# Access Compliance Report

### (Curb Ramps)

Intersection ID: 12006	Main Street: MEREDITH_AV	Cross Street: WESTERLY_HILLS_DR	Location: SE
ADA ID: 8C8D4CD34787	Ramp Type: Combination1	Initial Pass/Fail: Fail	Overall Compliance: No
Codes/Mitigation Info/Possible Solution		Field Measurements/Component Compliance	
Severity Score: 46.25

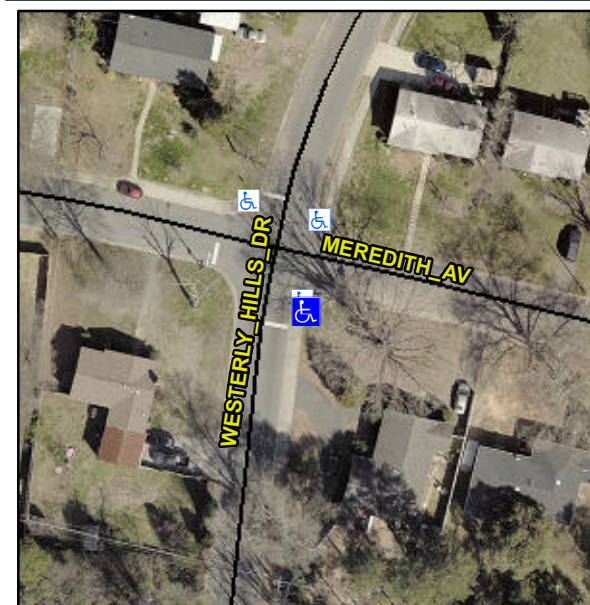
**RP & LT RP < 5%**

**Not Found, R304.5.1, R304.5.3, R304.3.2**

Compliance	Description	Data	Compliance	Description	Data
N/A	Ramp Length LT (in)	40.0	N/A	Ramp Length RT (in)	36.5
Yes	Ramp Width LT (in)	73.0	Yes	Ramp Width RT (in)	70.0
Yes	Ramp Slope LT (%)	2.5	No	Ramp Slope RT (%)	10.3
No	Ramp XSlope LT (%)	3.4	Yes	Ramp XSlope RT (%)	0.4
N/A	Ramp Length (in)	71.0	Yes	Ramp Slope (%)	4.6
No	Ramp Width (in)	46.5	No	Ramp XSlope (%)	7.6
N/A	Flare Type LT	N/A	N/A	Flare Type RT	N/A
N/A	Flare Slope LT (%)	N/A	N/A	Flare Slope RT (%)	N/A
N/A	Flare Traversable LT?	N/A	N/A	Flare Traversable RT?	N/A
N/A	Landing Length (in)	N/A	N/A	DWS Provided?	N/A
N/A	Landing Width (in)	N/A	N/A	DWS Contrast?	N/A
N/A	Landing Slope (%)	N/A	N/A	DWS Length (in)	N/A
N/A	Landing X Slope (%)	N/A	N/A	DWS Full Width?	N/A
N/A	Landing Curb? (Y/N)	N/A	N/A	DWS Offset (in)	N/A
N/A	Shared Landing?	N/A			
N/A	Gutter Ponding?	N/A	N/A	Gutter Slope (%)	N/A
N/A	Gutter Lip Ht (in)	N/A	N/A	Gutter X Slope (%)	N/A
N/A	Painted X Walk1?	No	N/A	Painted X Walk2?	N/A

**Remove & Replace Entire Ramp.**
